APPLICATION NO.	FILING DATE	FIRST NAMED INVENTOR	ATTORNEY DOCKET NO.	CONFIRMATION NO.
10/775,372	02/09/2004	Wayne Hartley	303.002	9922

**Office Action Summary**

### **DETAILED ACTION**

FIG A: US patent 723,033 to Roux, Figure 1. Lead lines and reference numbers added by the examiner.

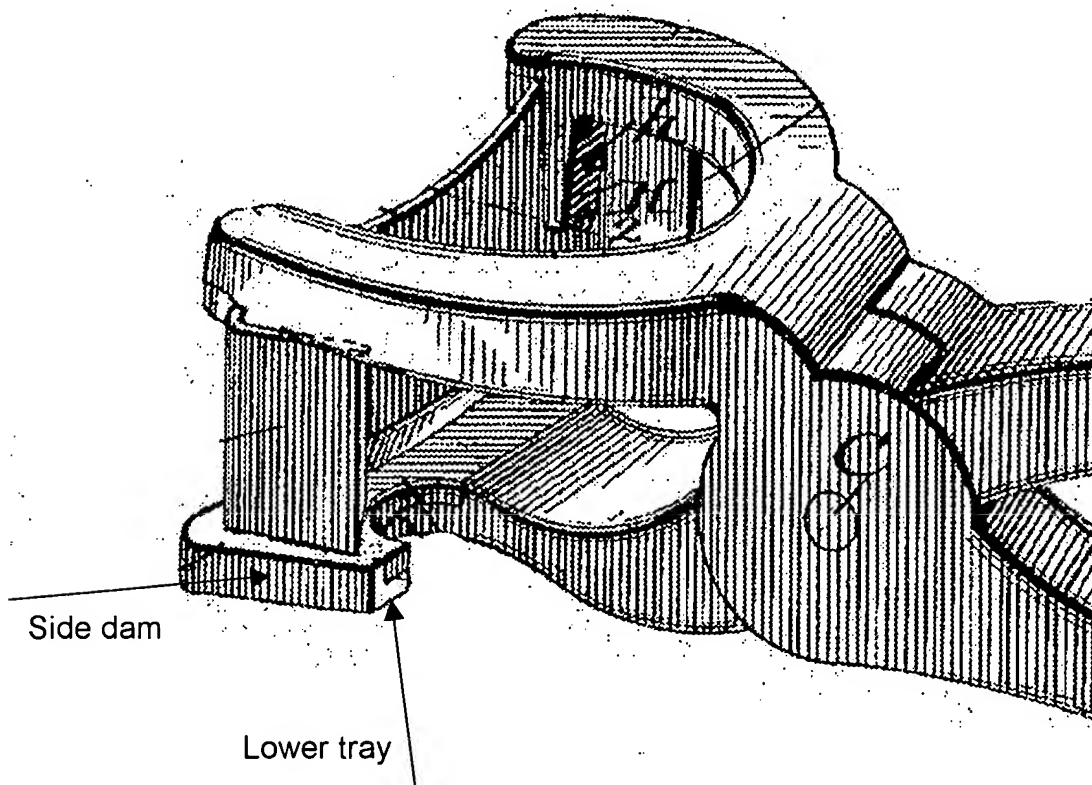
Roux discloses a device capable of clipping nails as claimed, including: a. a lower tray (bottom surface of bed plate D, see the *Figures* section at the end of this Office action); b. a first side dam (side wall of bed plate D, see *Figures* section) extending upwardly from a first side of said lower tray, said first side dam having a generally vertical slot (recessed area D') in an interior thereof; c. a second side dam (side wall of bed plate D on the opposite side) extending upwardly from a second side of said lower tray that is opposite said first side of said lower tray, said second side dam having a generally vertical slot (D') in an interior thereof; d. an upper jaw (including curved arms F) that is displaceable relative to said lower tray; e. a blade (E) that is pivotally mounted to a lower portion of said upper jaw, said blade (E) extending below said upper jaw and into said generally vertical slot (D') in said first side dam and said generally vertical

slot (D') of said second side dam, wherein said blade (E) travels in said generally vertical slot (D') in said first side dam and said generally vertical slot (D') in said second side dam when said upper jaw is displaced relative to said lower tray. The blade (E) can be considered "pivotally mounted" as claimed because it is mounted to an upper jaw that pivots about a pivot point C. In addition, the Roux device anticipates the limitation regarding the blade extending into and traveling in the slot because the blade of the Roux device pierces the cushion G during a cutting operation. It is inherent the blade pierces the cushion during operation because it is disclosed the cushion is made from a soft material and can be removed and replaced. See col. 1, lines 32-38. Finally, while the Roux blade may not be precisely vertical to the lower tray during its full range of motion, it will generally be vertical during a small range of motion, such as to cut a thin work piece, and thus anticipates the claim.
